Dutton & Jett Note Block Diagram -- AMD Brazos 2.0

PROJECT : LI2A

LI2A-AMD Schematic EC Tracking Record (Before A stage) 2011.11.10

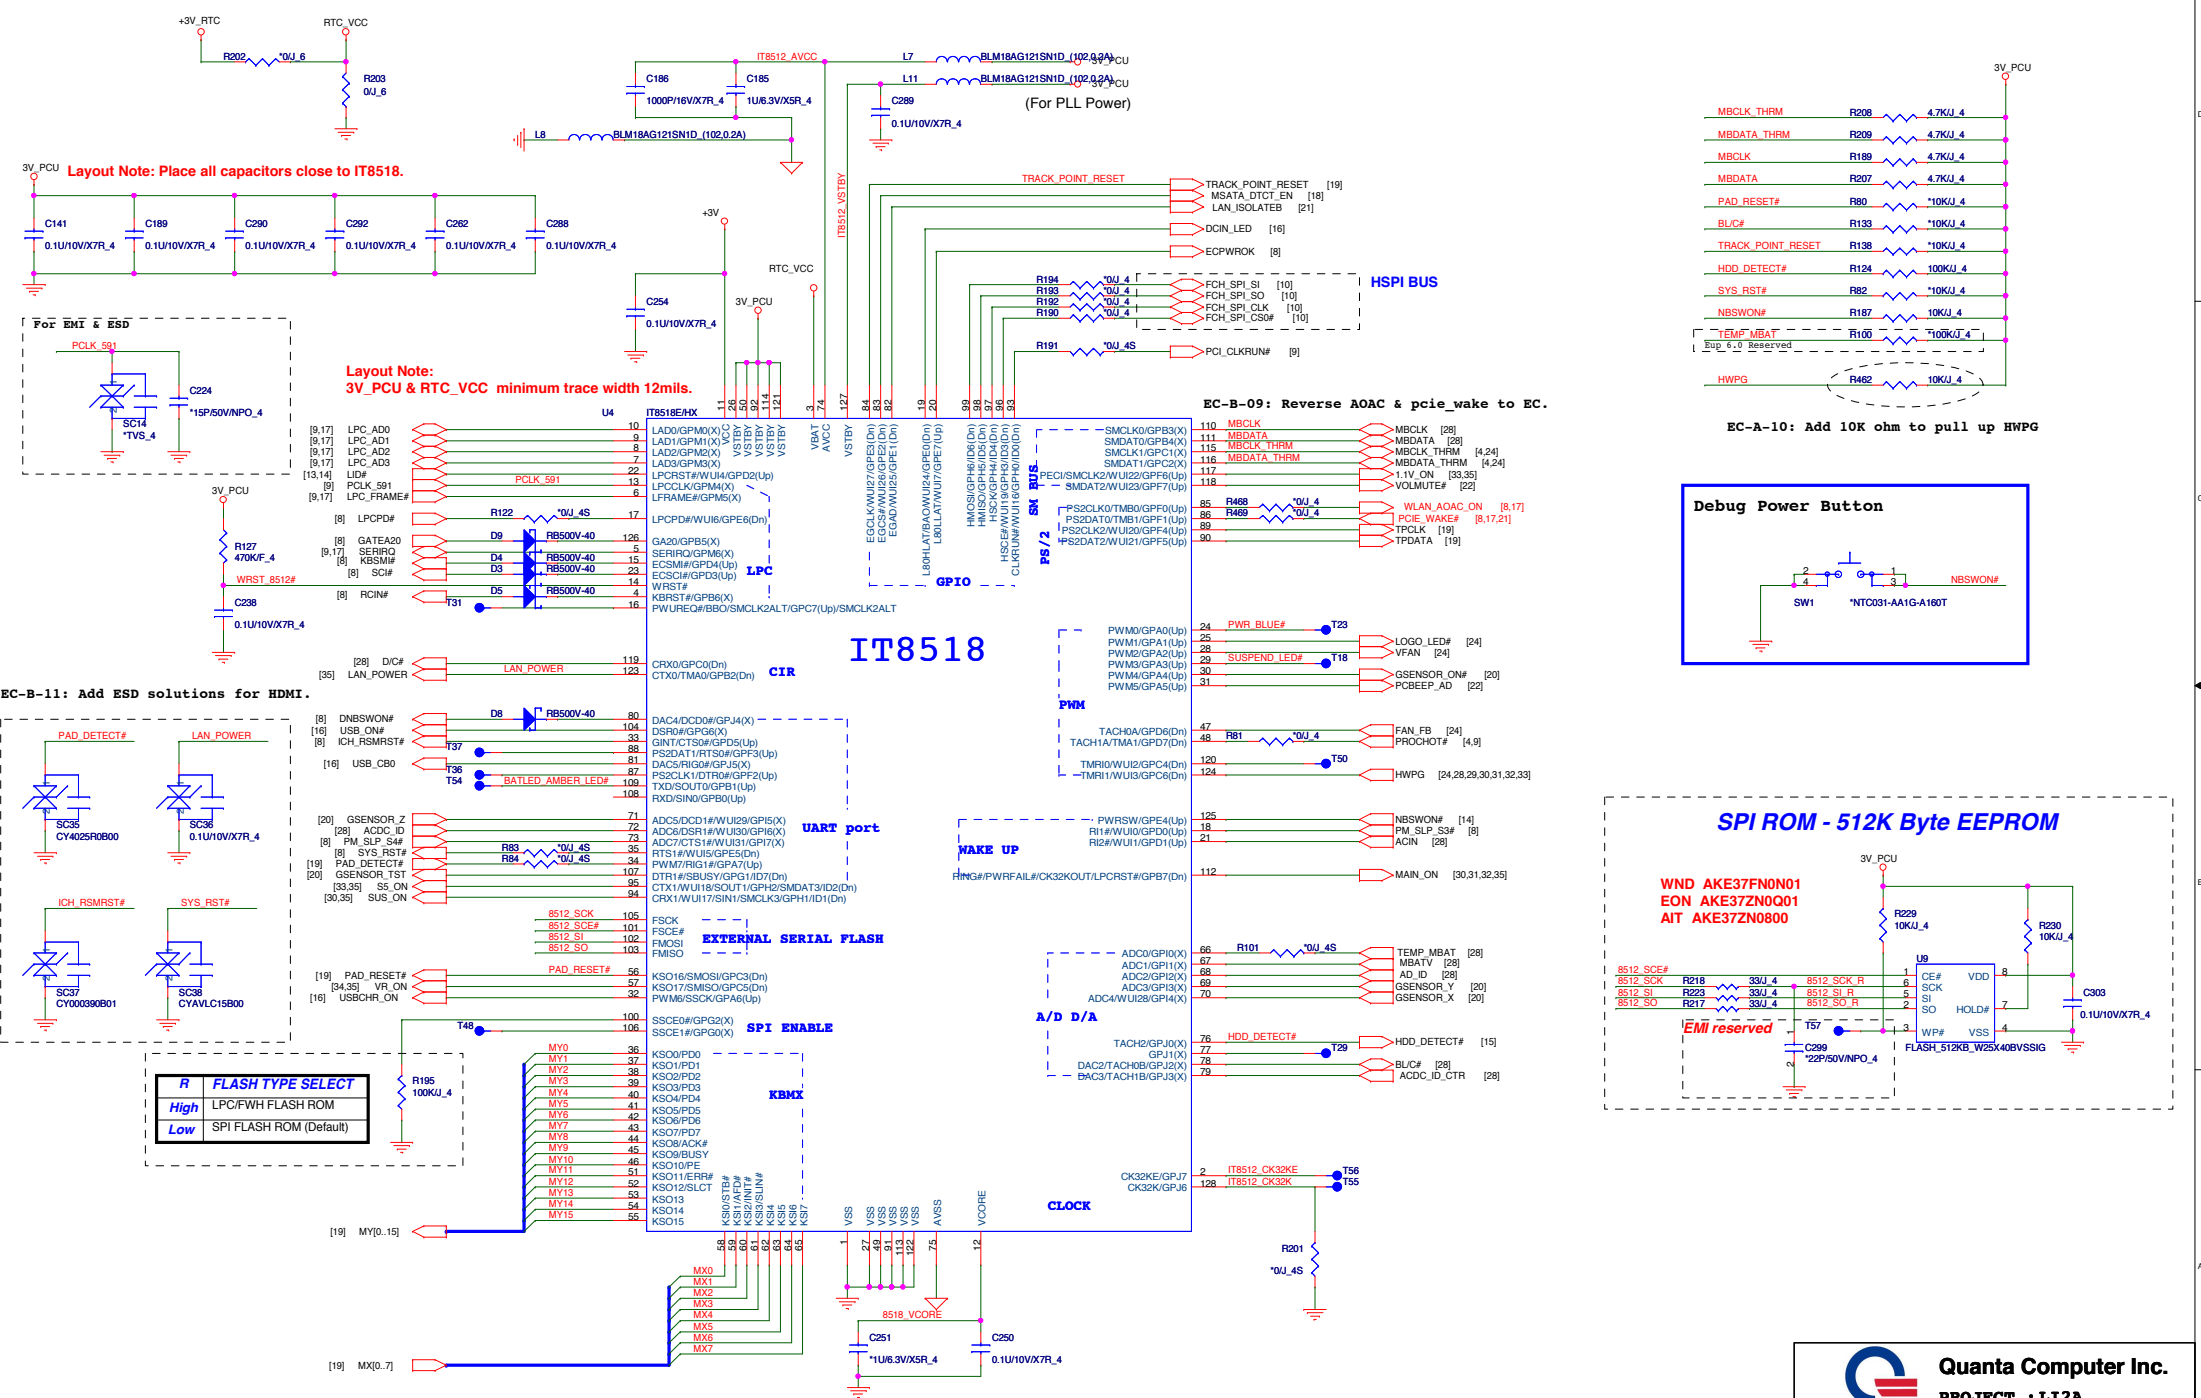
EC-B-11: Add ESD solutions for HDMI.

EC-B-09: Reverse AOAC & pcie_wake to EC.

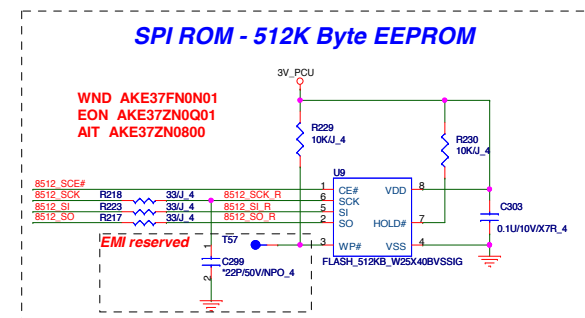
EC-A-10: Add 10K ohm to pull up HWPG

EC-A-10: Add 10K ohm to pull up HWPG
Add: CS31002JB28 - R462

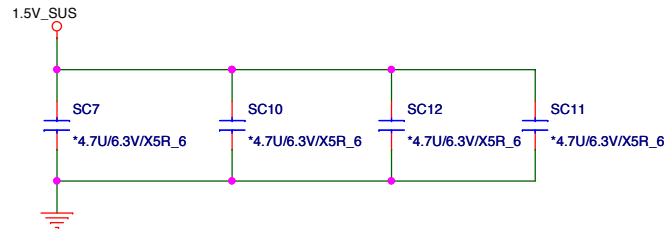
EC-15: Reserved ESD components by ESD engineer's suggestions

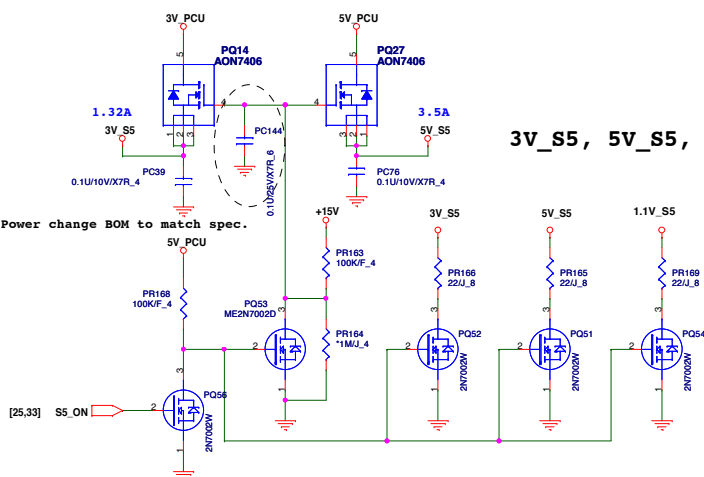
EC-A-14: Power change BOM to match spec.

EC-A-14: Power change BOM to match spec.
Change: From CH41006K911 to CH41004K910 - PC91 & PC144

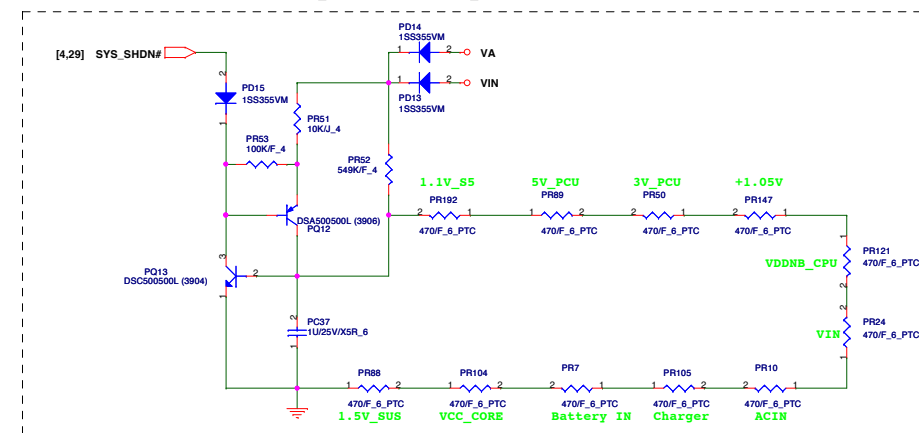
EC-11: Modify PTC NAME: PR9178(1.1V_S5), PR9179(5V_PCU), PR9180(3V_PCU)PR9181(+1.05V), PR9184(VDD_NBCPU), PR9189(VIN), PR9194(ACIN), PR9193(CHARHER), PR9192(Battery IN), PR9191(VCC_CORE), PR9196(1.5V_SUS).
